PROJECT
**31 Grasmere Gardens, Bridgegate
Bristol, BS30 5XW**

DRAWING TITLE
**Extension + Internal Reorganisation
Existing Conditions**

SCALE @ A1	DRAWN BY:
AS SHOWN	CA
DATE	CHECKED BY:
NOV 2020	CA
JOB NUMBER	DRAWING NUMBER
20.090	AL(0)001
	REVISION LETTER
	A

EXISTING BLOCK PLAN
scale 1:200

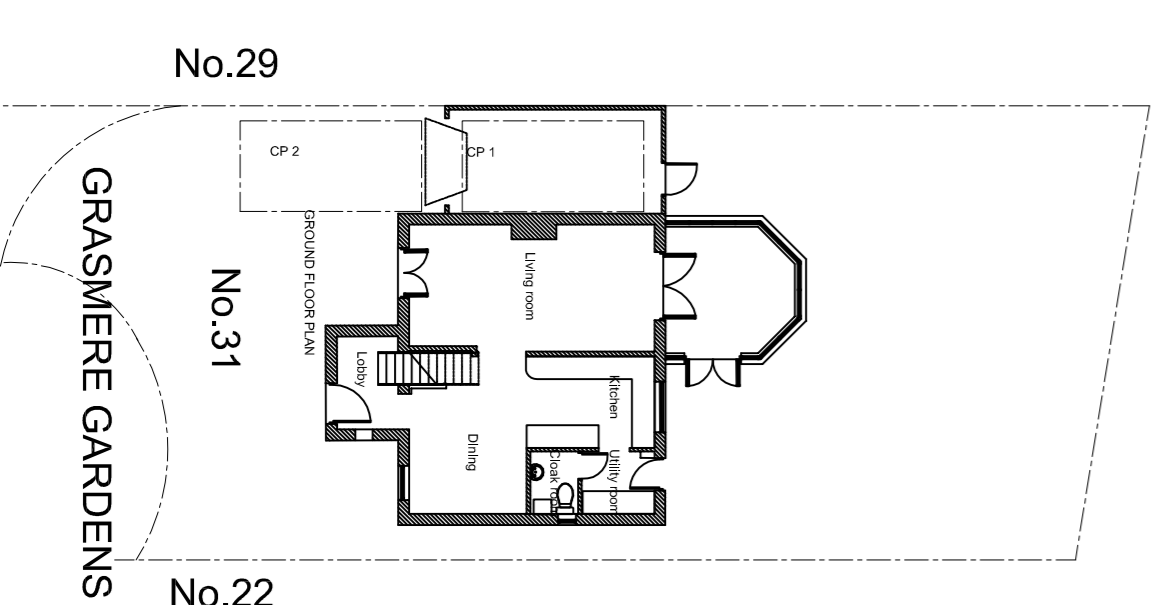
REV A Parking spaces shown as requested by S Gies Planning 13.02.2024
